UNITED STATES
NUCLEAR REGULATORY COMMISSION
WASHINGTON, D.C. 20555-0001

BROWNS FERRY NUCLEAR PLANT, UNIT 2

AMENDMENT TO FACILITY OPERATING LICENSE

Amendment No. 254
License No. DPR-52

Figure 3.4.1-1
THERMAL POWER VERSUS CORE FLOW STABILITY REGIONS

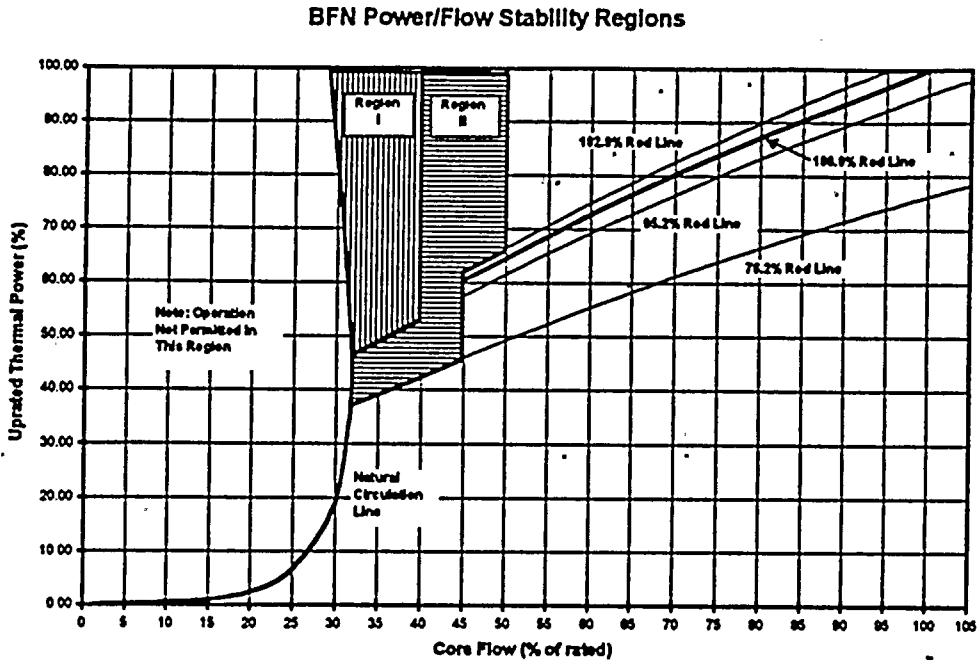
determined to be bounded by the 76.2% rod line and the 50% core flow line. BFN conservatively implements this generic region with the "Operation Not Permitted" Region and Regions I and II of Figure 3.4.1-1. This conforms to Reference 3 recommendations. Operation is permitted in Region II provided neutron flux noise levels are verified to be within limits. The reactor mode switch must be placed in the shutdown position (an immediate scram is required) if Region I is entered.

Two recirculation loops are required to be in operation with their flows matched within the limits specified in SR 3.4.1.1 to ensure that during a LOCA caused by a break of the piping of one recirculation loop the assumptions of the LOCA analysis are satisfied. With the limits specified in SR 3.4.1.1 not met, the recirculation loop with the lower flow must be considered not in operation. In addition, the core flow expressed as a function of THERMAL POWER must be outside Regions I and II and the Operation Not Permitted Region of Figure 3.4.1-1.

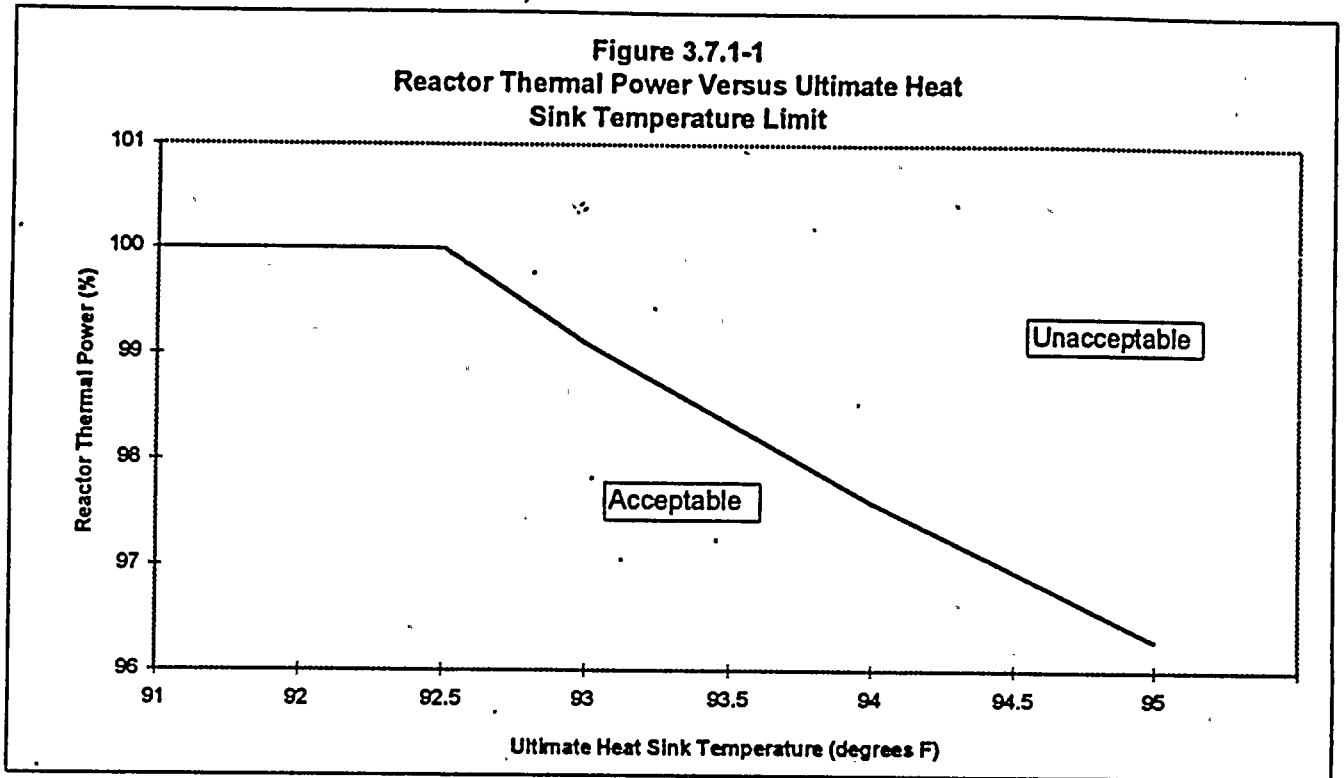
The OPERABILITY of the UHS for RHRSW is based on having a maximum water temperature within the limits specified in Figure 3.7.1-1.

Figure 3.4.1-1
THERMAL POWER VERSUS CORE FLOW STABILITY REGIONS

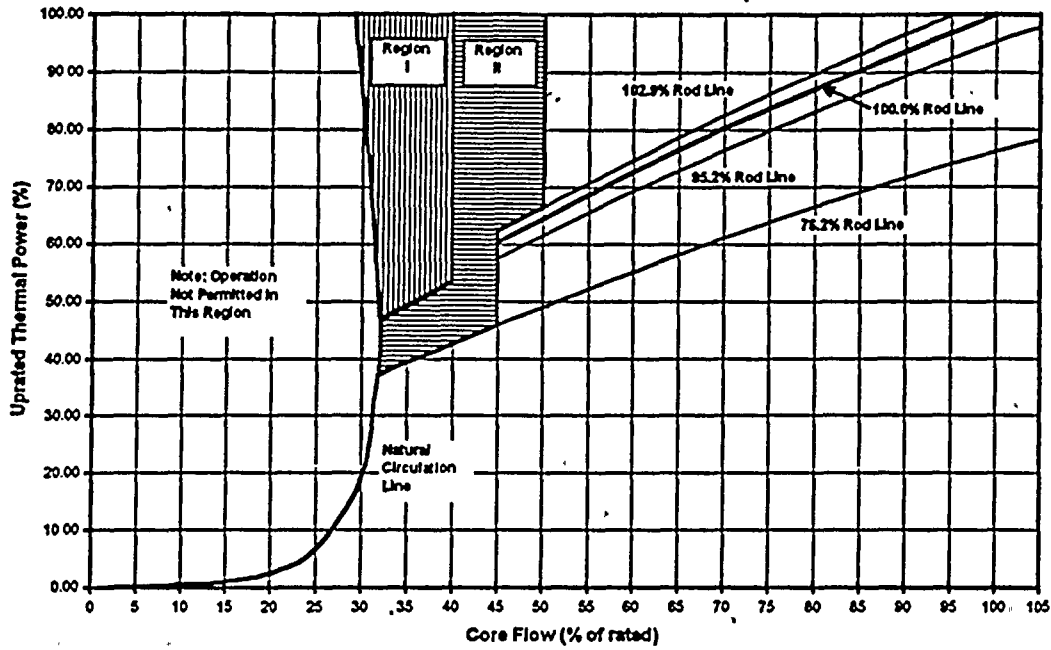
determined to be bounded by the 76.2% rod line and the 45% core flow line. BFN conservatively implements this generic region with the "Operation Not Permitted" Region and Regions I and II of Figure 3.4.1-1. This conforms to Reference 3 recommendations. Operation is permitted in Region II provided neutron flux noise levels are verified to be within limits. The reactor mode switch must be placed in the shutdown position (an immediate scram is required) if Region I is entered.

Two recirculation loops are required to be in operation with their flows matched within the limits specified in SR 3.4.1.1 to ensure that during a LOCA caused by a break of the piping of one recirculation loop the assumptions of the LOCA analysis are satisfied. With the limits specified in SR 3.4.1.1 not met, the recirculation loop with the lower flow must be considered not in operation. In addition, the core flow expressed as a function of THERMAL POWER must be outside Regions I and II and the Operation Not Permitted Region of Figure 3.4.1-1.

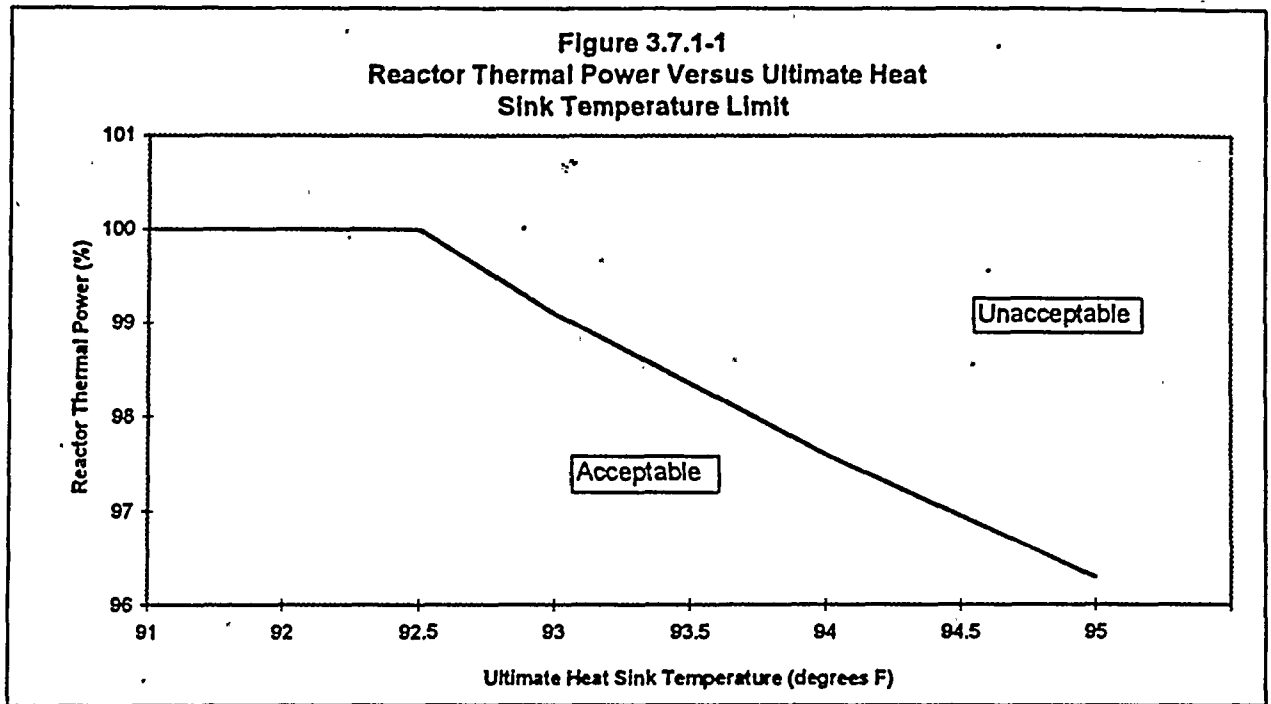
The OPERABILITY of the UHS for RHRSW is based on having a maximum water temperature within the limits specified in Figure 3.7.1-1.
